## **ERRATA CORRIGE**

***Please find here attached the page that has to be replaced in the basic Service Bulletin n°189-295 Rev. /.***

**N° 189-295**

**ATA 34 – GLIDE SLOPE ANTENNA INSPECTION**

**Figure 3**

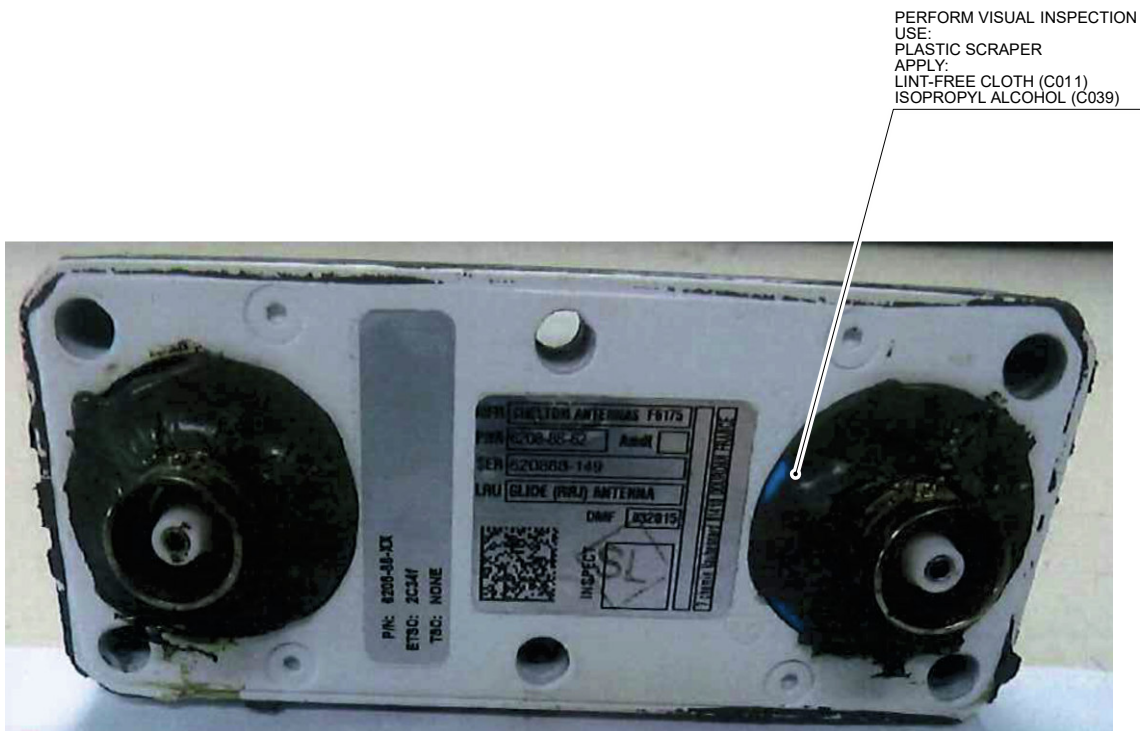
- **PAGE 14 “Figure 3”**

The description of the bottom picture “VIEW D – INCORRECT ASSEMBLY PRACTICE” has been changed.

***Was:***

“GLIDE SLOPE ANTENNA P/N 6208-88-62, ANTENNA CORRECTLY MOUNTED, PRESENCE OF SEALANT IS NOT FOUND”

***Becomes:***

“GLIDE SLOPE ANTENNA P/N 6208-88-62, ANTENNA INCORRECTLY MOUNTED, PRESENCE OF SEALANT IS FOUND”
